The case against a proposed relaxation of out-of-band noise and spurious specifications for DOCSIS Edge-QAM RF devices

Submitted by Broadband Innovations, Inc.

June 13, 2005

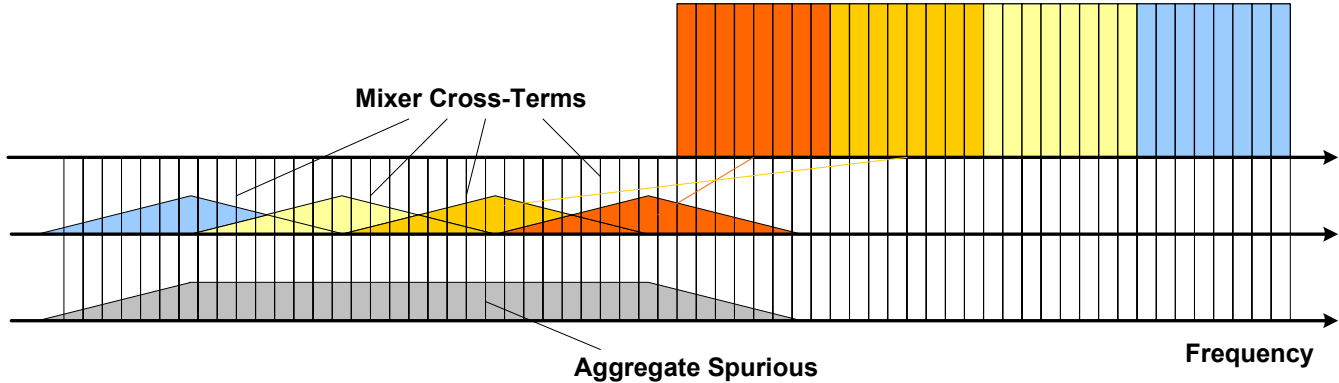
In general, satisfactory Self-Aggregation of noise and spurious from a *single* product type provides no assurance of a satisfactory protection across *different* product types. In fact, Self-Aggregation of spurious and noise has very little bearing on potential Cross-Type spurious aggregation. We show below that spurious component’s frequency movement with channel assignment is *exactly* the nature of certain mixer cross-terms for which the JPSA proponents actually sought specification relief in suggesting Item 5(d).

Returning to Figure 1, it shows a disturbing trend for the future if Items 5(d) and 8 remain: As the number of channels in a QAM block increases, permitting these mixer cross terms to reach the levels in Item 8, would result in wide -63 dBc spurious noise plateau on other channels. In fact, contrary to notions advanced by the JPSA proponents, the total self-aggregating specifications of Item 7 *does not* limit the number of channels in such -63 dBc plateaus because Item 7 is set for -55 dBc and because the permitted -63 dBc aggregate limit in Item 8 *does not* include all spurious and noise power. It should be noted that because over the tuning range, there is no escape from a condition in which these mixer terms fall immediately near the desired channels, allowance of these mixer cross-terms to reach levels of -63 dBc would necessarily also require relaxation of the third adjacent channel specifications. Therefore, look for the JPSA proponents’ future attempts to expand the relaxation of item 5(d) into the third adjacent channel. Clearly, if the exemptions in Item 5(d) of the JPSA specifications were to be adopted, operators would have insufficient protection from the adverse effects of these modulated mixer spurious components - *not even the protection they enjoy today under the current DOCSIS RFI*. Thus, the JPSA exemption is a step back to inferior protection and a regression in specifications¹.

Figure 2. Cross-Type aggregation of second order mixer spurious components from 7 upconverter types having distinct 2nd IF frequencies that are tuned to distinct channels shown by the colored circles on the horizontal axis.

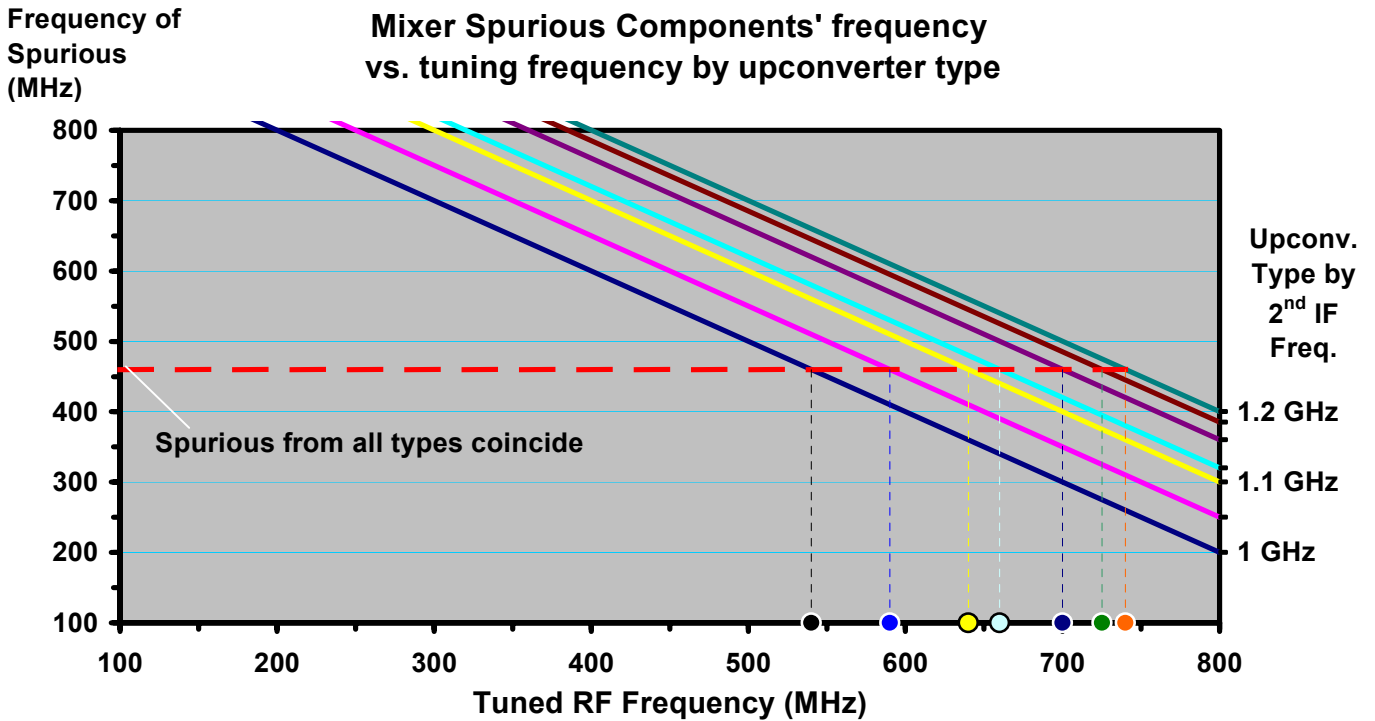
An example in double conversion upconverters is the well known second order mixer spurious term having a spurious RF center frequency F_{spur} meeting the relation $F_{spur}=2 \cdot F_{IF} - F_{LO2} = F_{IF} - F_{RF}$, where F_{IF} is the second IF frequency, F_{LO2} is the frequency of the second high-side local oscillator and F_{RF} is the RF frequency tuned to. The modulated distortion components from this mixer spurious terms have approximately a triangular power spectral densities as shown in Figure 1. The exact relation between the spurious term frequency and the RF frequency depends on the IF frequency. As evident from this simple frequency relationship, although there is some overlap between terms from devices tuned to different frequencies, the center frequency of spurious components from *all* upconverters having the *same* IF frequency (same type) are *guaranteed not to align* when they are tuned to distinct channels, enabling compliance with Self-Aggregate spurious specifications. However, this non-coincident spurious property disappears when the IF frequencies of the upconverters are distinct. In such situations, the ability to find a specific setting in which spurious alignment from *all* distinct upconverter types cannot be characterized as “improbable” but rather, as a *certainty* in many sets of distinct channel assignments. This is shown in Figure 2, where the center frequency of the second-order mixer spurious is plotted vs. the upconverter output frequency for different types of IF frequencies. The example in Figure 2 shows 7 types of upconverters having distinct second IF frequencies in the range of 1 GHz to 1.2 GHz. In the broken lines example of this figure, *all* shown types of upconverters produce a spurious component centered on 460 MHz when tuned to the respective frequencies shown by colored circles on the Tuned RF Frequency axis. It is also clear from this figure that spurious alignment not only on 460 MHz but on essentially every frequency in the range can occur for many other similar tuning configurations which have the same tuning frequency increments among upconverter types.

Of course, it is possible that if one tunes at random 7 types of upconverters there may be an alignment among less than 7 devices or a partial alignment where the spurious of width $2N_1$ channels of one type partially overlaps with that from another type having a spectral width of $2N_2$ channels. It is also possible that there will be no alignment among any types, but all these possibilities would be left to chance at the

operator’s risk. Suffice it to say that this example demonstrates that no matter how many distinct types of upconverters are employed, *it is certain* that one can always find *many* tuning configurations for which the spurious components from *all* such upconverter types are aligned, realizing the worst-case aggregation conditions.
